SAFETY EVALUATION  
FOR THE  
VIRGIL C. SUMMER NUCLEAR STATION  
TRANSITION TO WESTINGHOUSE 17x17 VANTAGE 5 FUEL

SOUTH CAROLINA ELECTRIC & GAS COMPANY  
VIRGIL C. SUMMER NUCLEAR STATION  
DOCKET NO. 50-395

MAY, 1988

Figure 2.1-1 Reactor Core Safety Limit - Three Loops in Operation

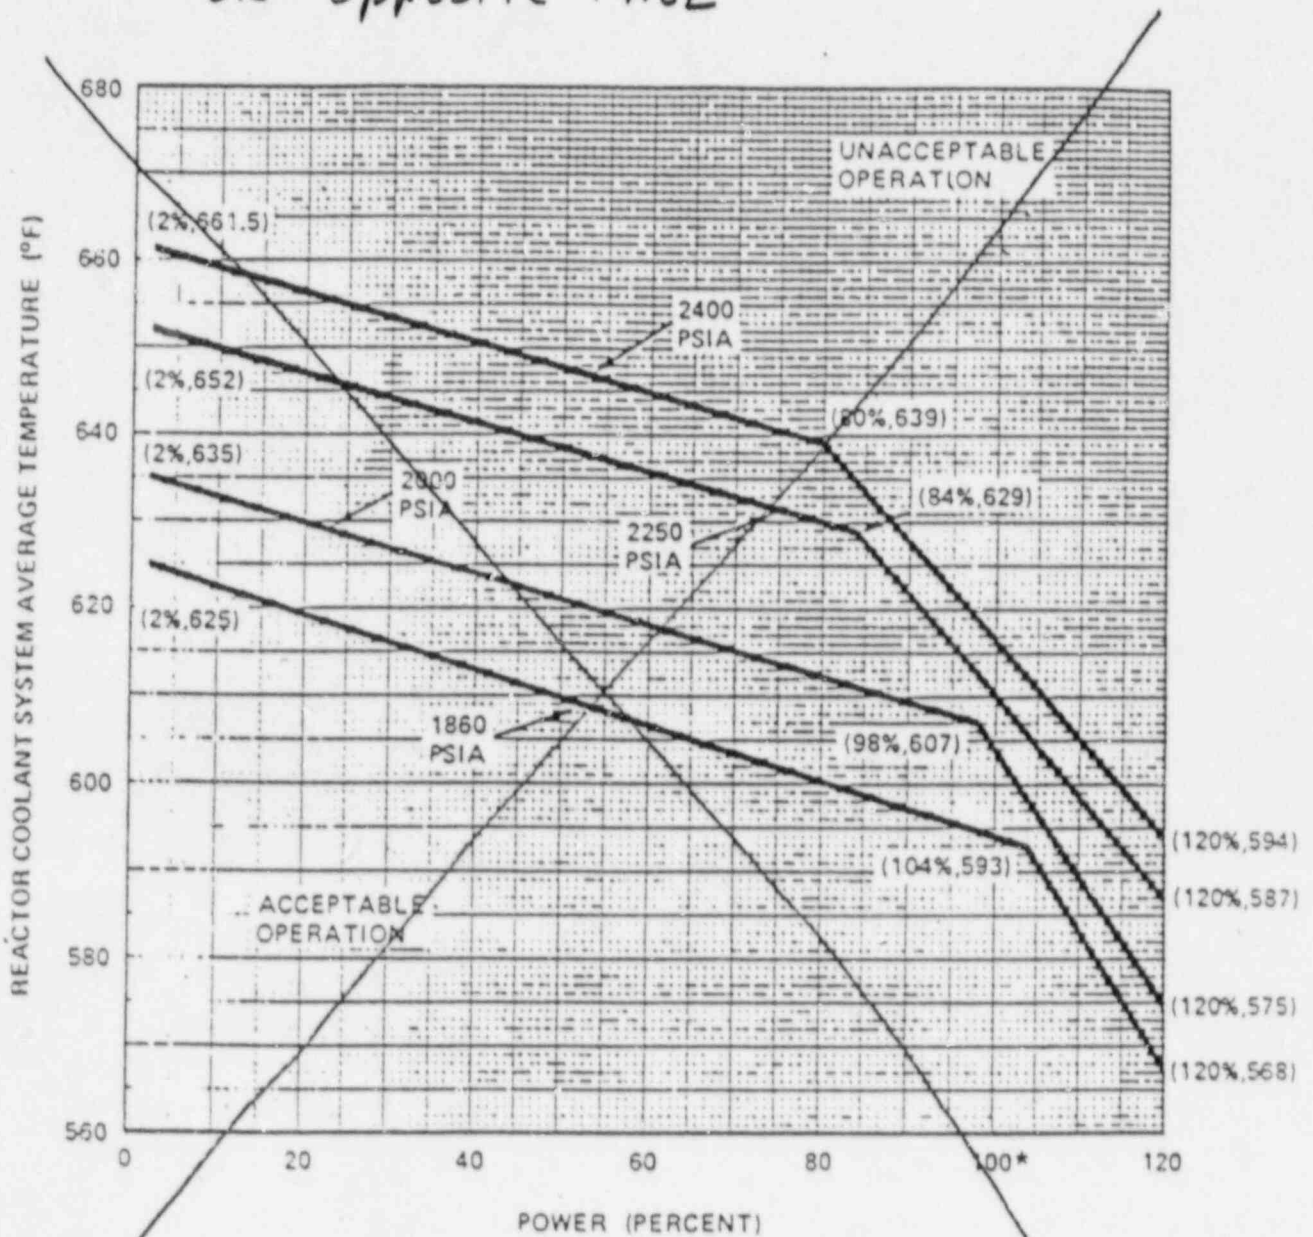
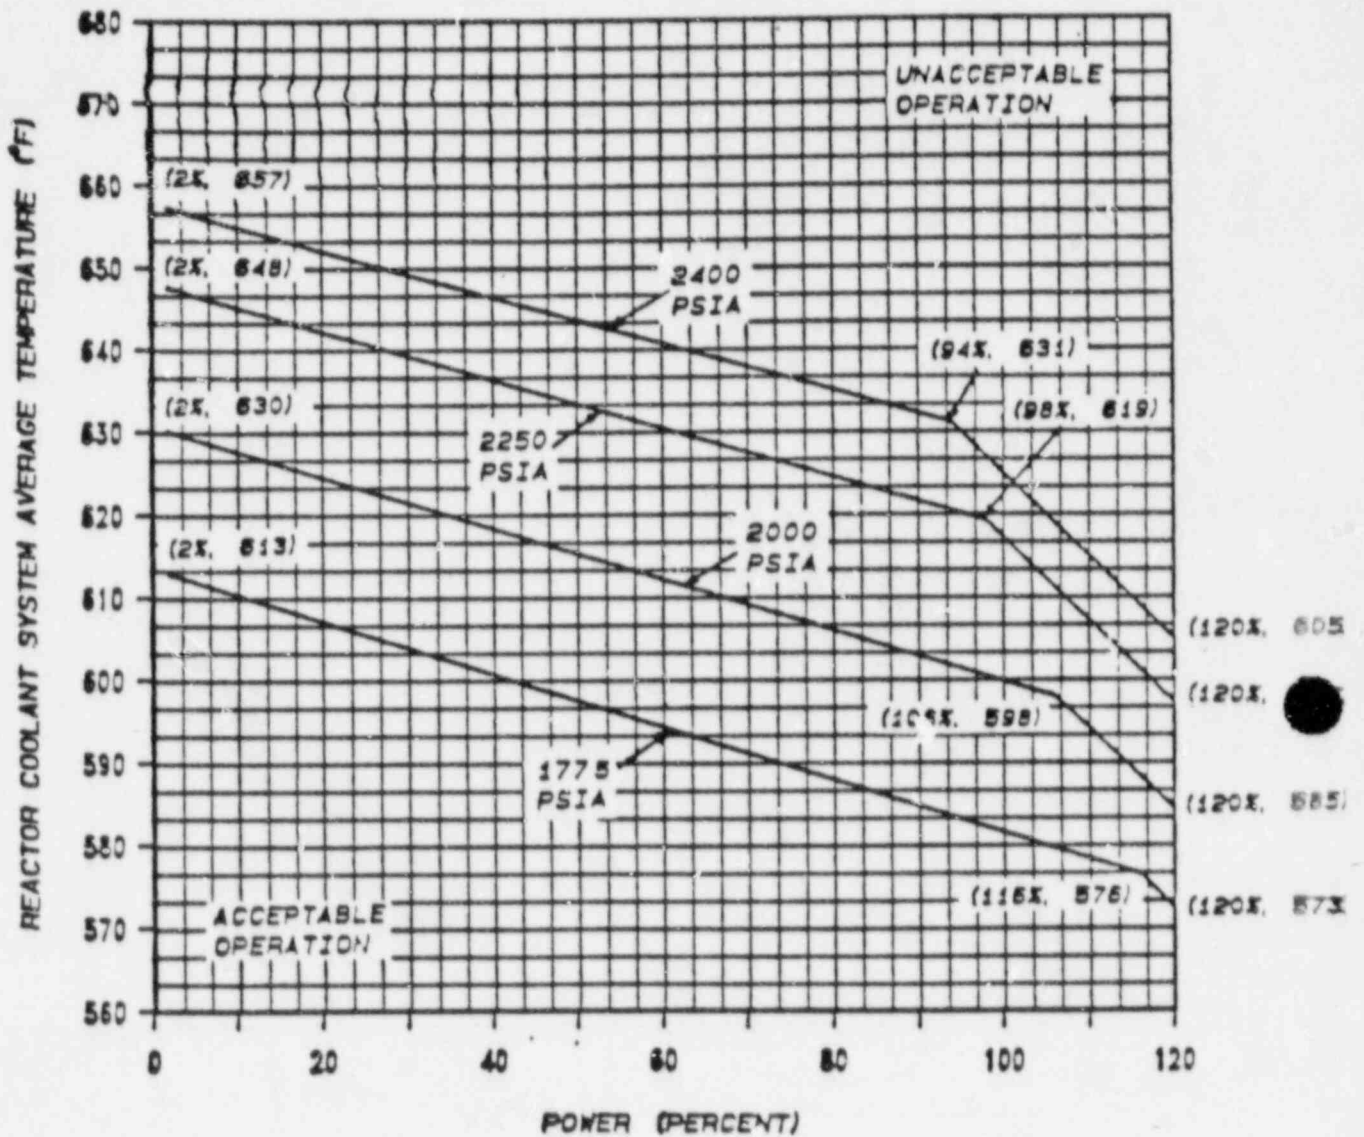
<u>PAGE</u>	<u>SECTION</u>	<u>DESCRIPTION OF CHANGE</u>	<u>JUSTIFICATION</u>
2-1	2.1.1	Delete reference to two loop operation	Two loop operation is not currently licensed
2-2	Figure 2.1-1	Core limits are revised	Core limits are revised for Vantage 5 fuel due to ITDP, new peaking factors and reduced RCS flow
2-5 2-8 2-9 2-10	Table 2.2-1	Setpoints and Thermal Design Flow (TDF) are changed	Setpoints and TDF are consistent with the new safety limits, instrument uncertainty and reduced flow
B 2-1	Bases 2.1.1	Discussion of Thermal and Hydraulic analysis	The analysis is based on ITDP methodology and the WRB-1 and -2 correlations
B 2-4	Bases 2.2.1	DNBR limit replaced by "safety analysis DNBR limit"	Future changes in analyses will not require a change in Bases
3/4 1-3a	Figure 3.1-3	Changed shutdown margin for Modes 3, 4 and 5	This is based on reanalysis of boron dilution with Vantage 5 fuel
3/4 1-4	3.1.1.3	Changed the MTC limits	This is based on Vantage 5 fuel

REPLACE WITH NEW  
 FIGURE 2.2-1  
 ON OPPOSITE PAGE

FIGURE 3.1-3  
REQUIRED SHUTDOWN MARGIN  
(MODES 3, 4 & 5)

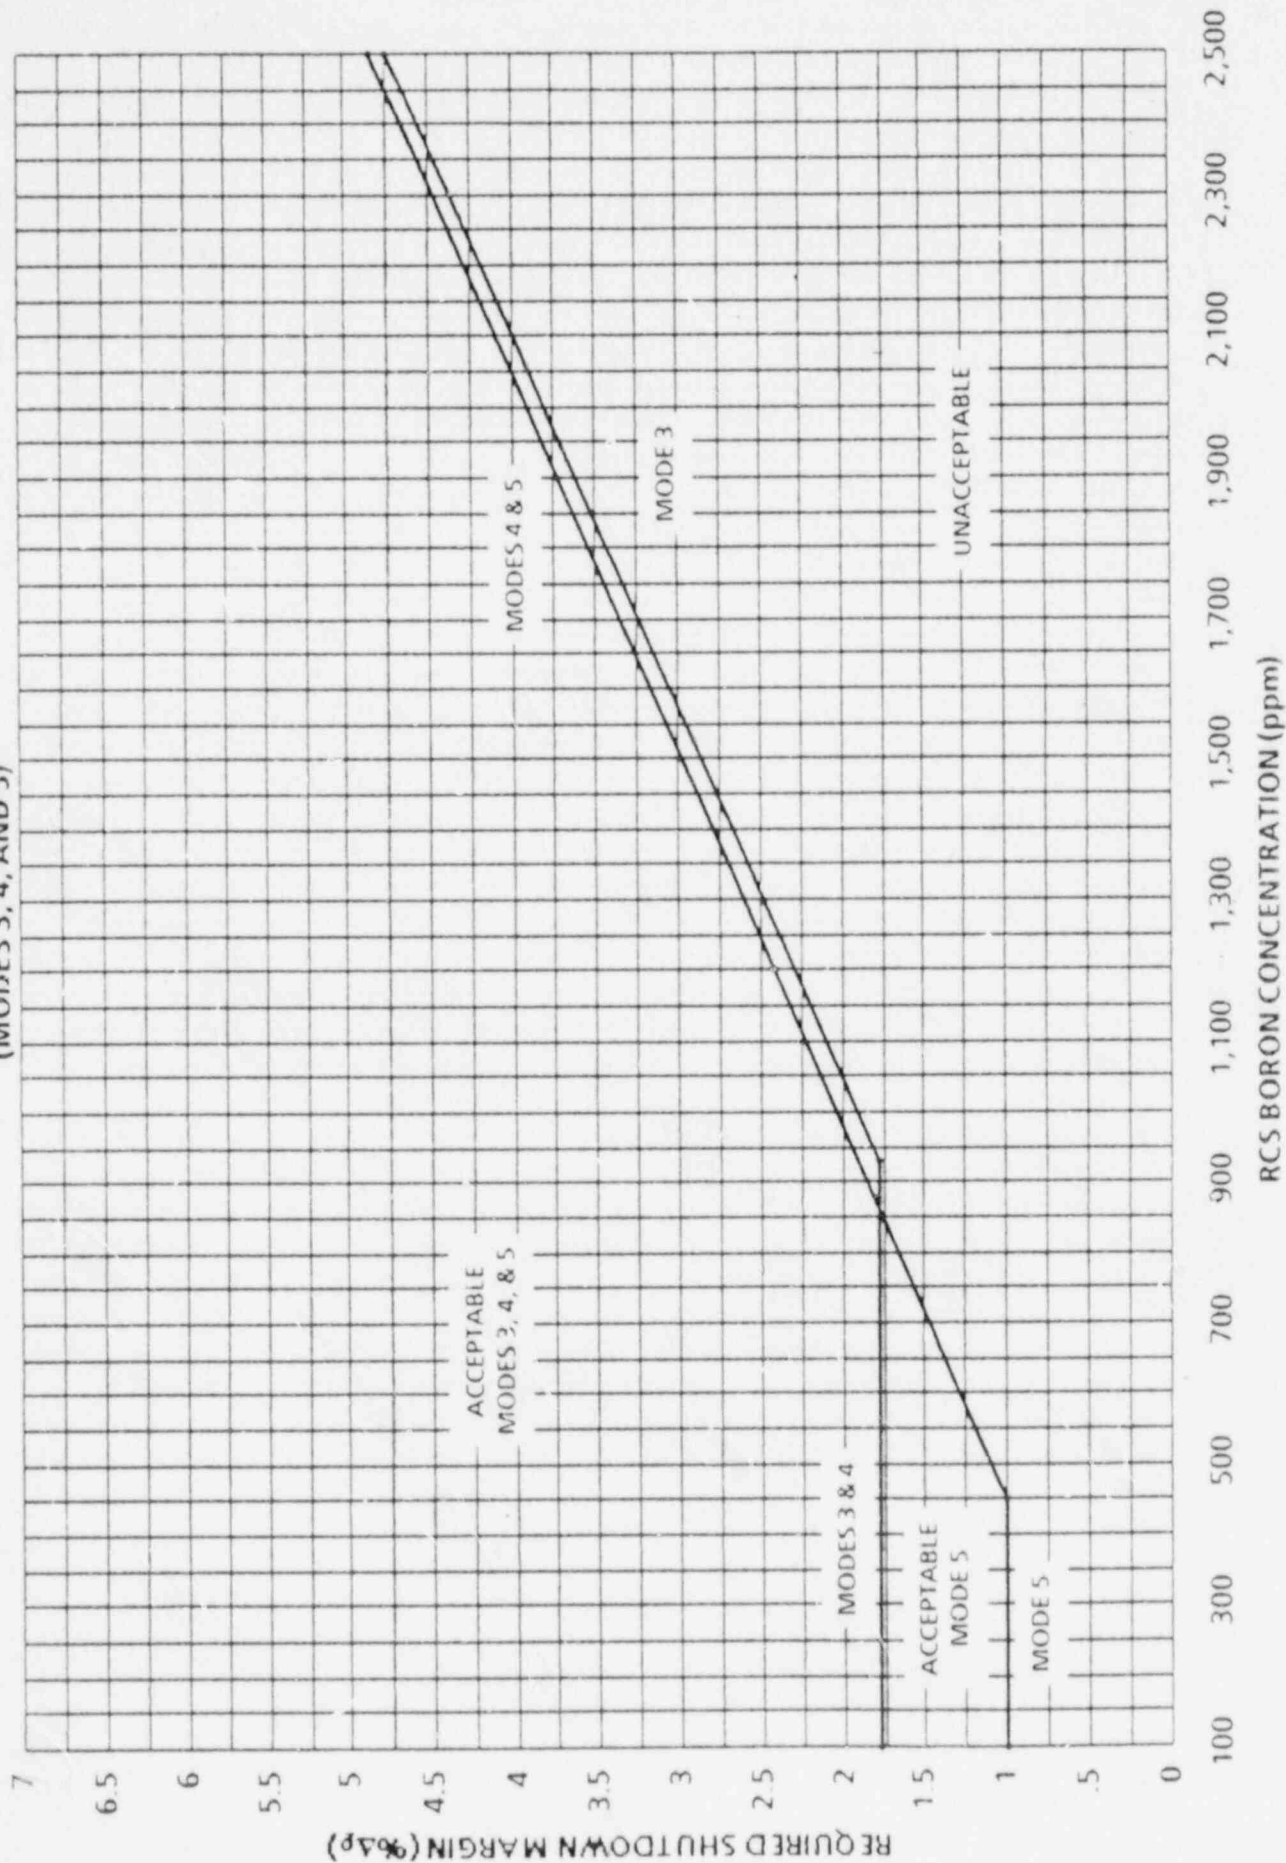
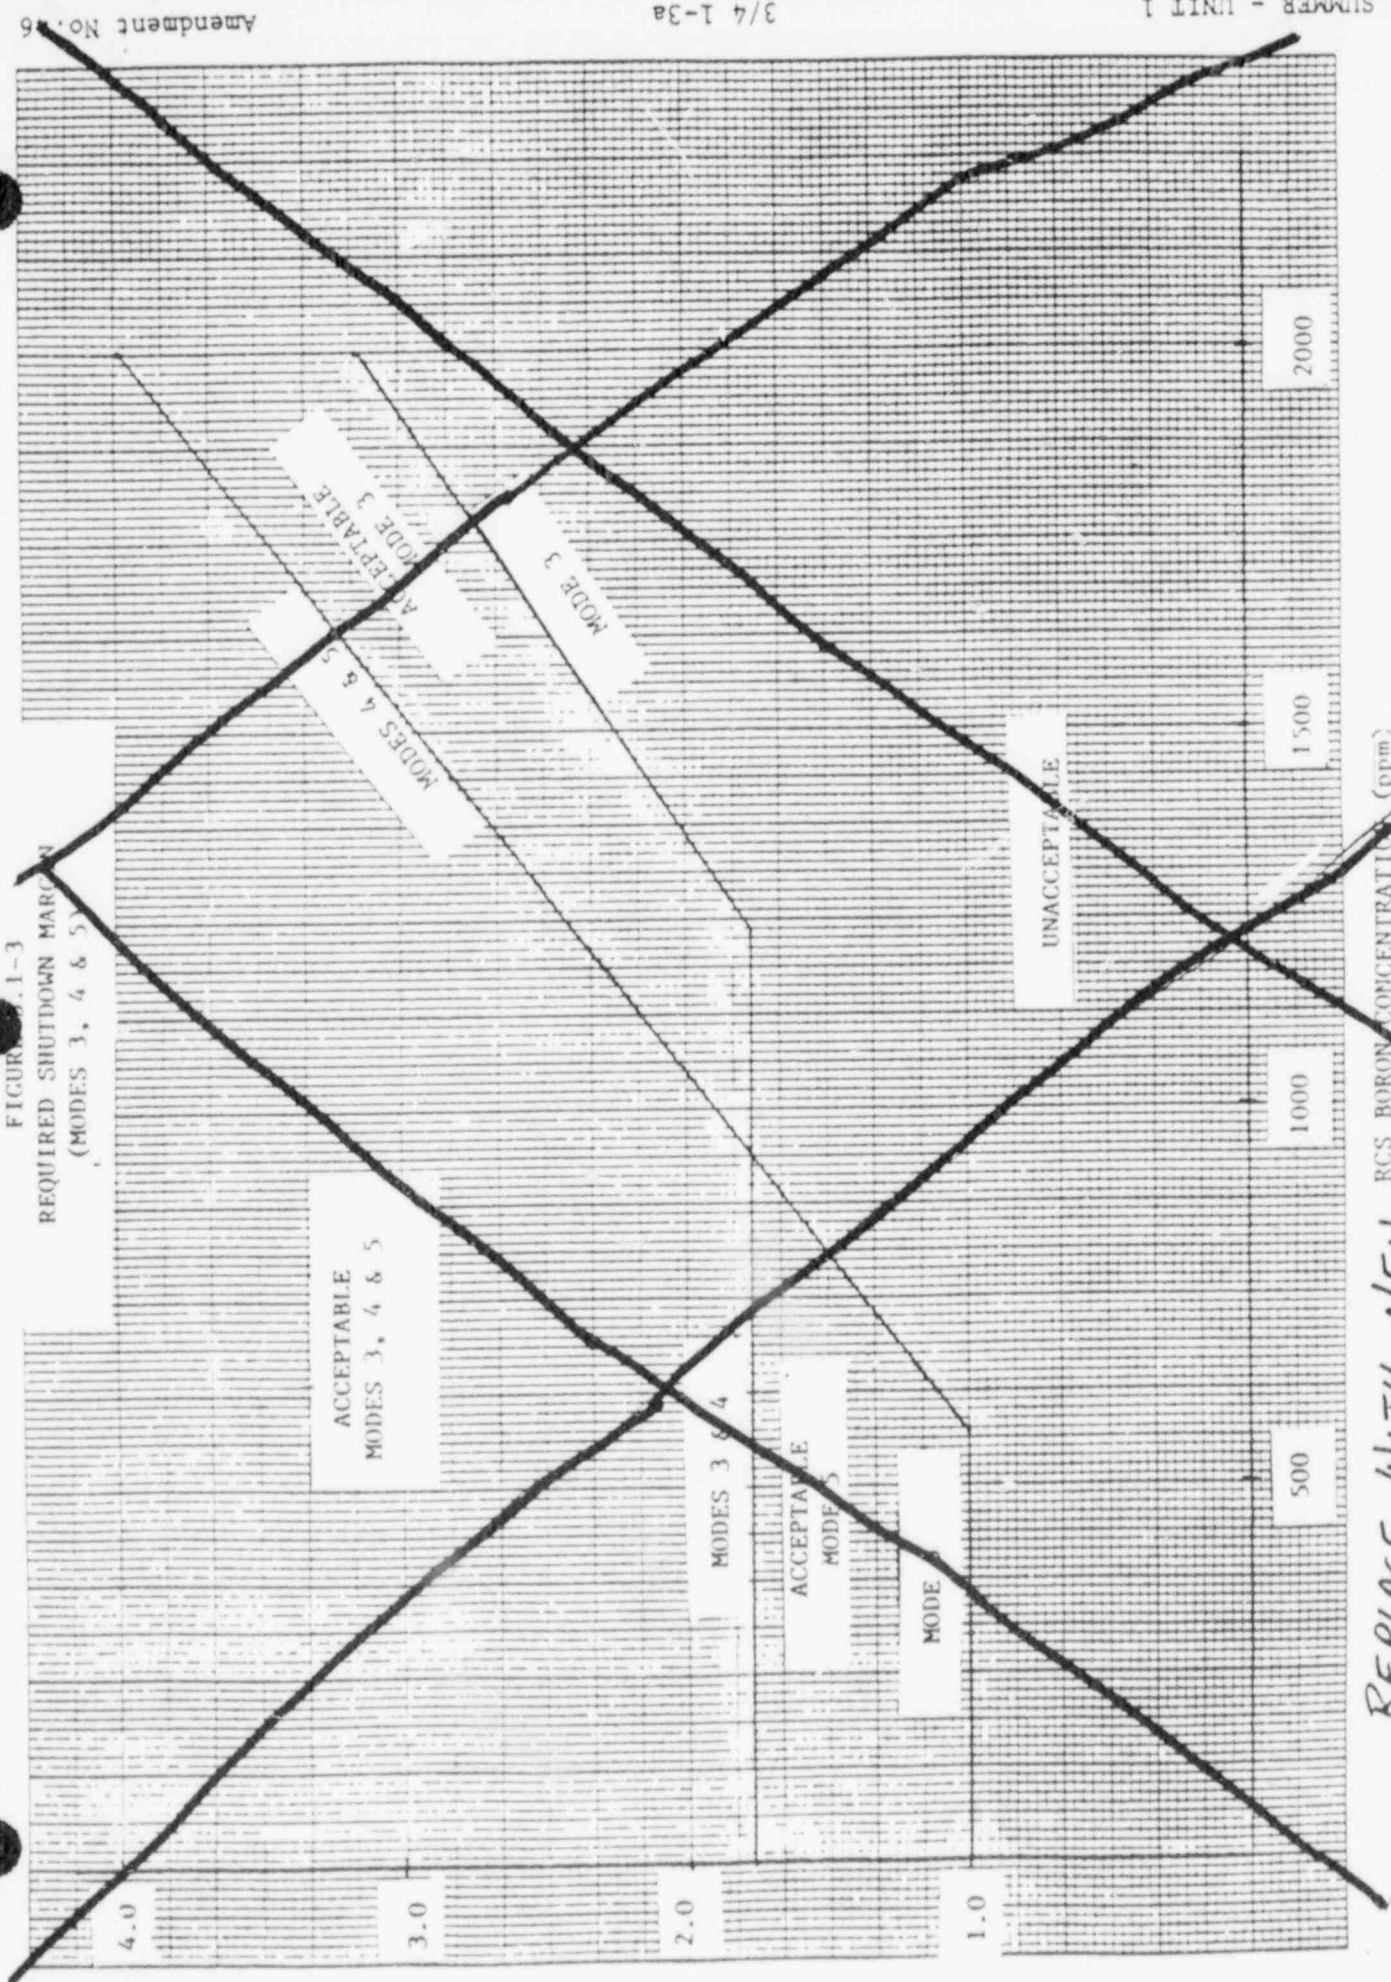
Figure 3.1-3 of the VCSNS Technical Specifications defines shutdown margin requirements as a function of average RCS boron concentration during Modes 3, 4, and 5. The proposed revisions are based on the reanalyses of the boron dilution event with VANTAGE 5 fuel (see the Transition Safety Evaluation) and are required to maintain the current bases of the Technical Specification.

REPLACE WITH NEW  
FIGURE 3.1-3 ON  
OPPOSITE PAGE.

FIGURE 3.1-0  
MODERATOR TEMPERATURE COEFFICIENT VS POWER LEVEL

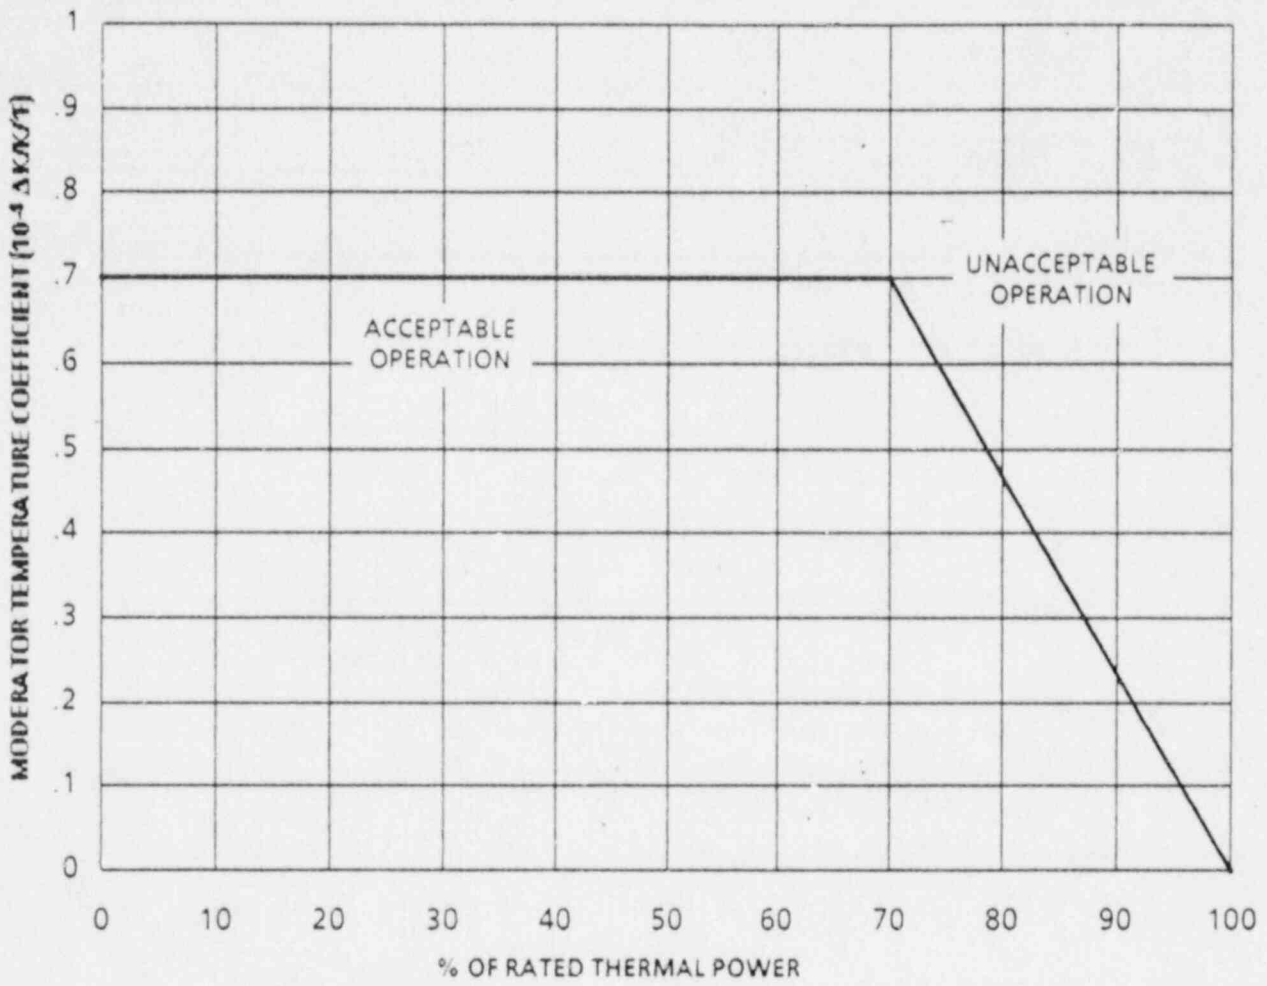
- a. Less positive than ~~0~~ <sup>the limits shown in Figure 3.1-0, and</sup> ~~delta k/k/°F~~ for the all rods withdrawn, beginning of cycle life (BOL), hot zero THERMAL POWER condition.
- b. Less negative than ~~-4.2~~ <sup>-5.0</sup>  $\times 10^{-4}$  delta k/k/°F for the all rods withdrawn, end of cycle life (EOL), RATED THERMAL POWER condition.

Figure 3.2-1 Axial Flux Difference Limits as a Function of Rated Thermal Power

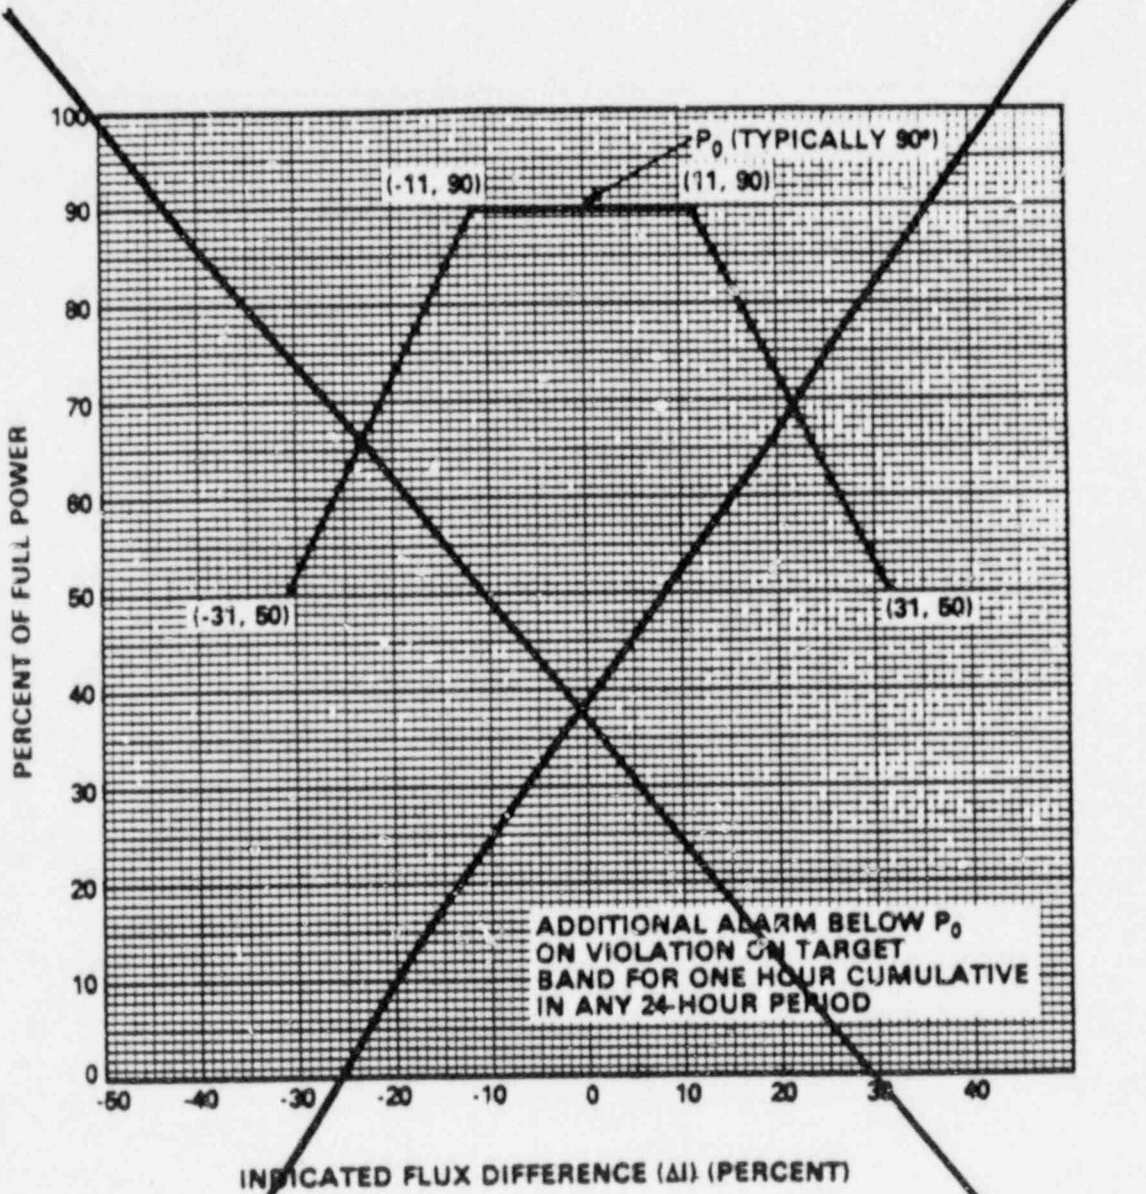
DELETE
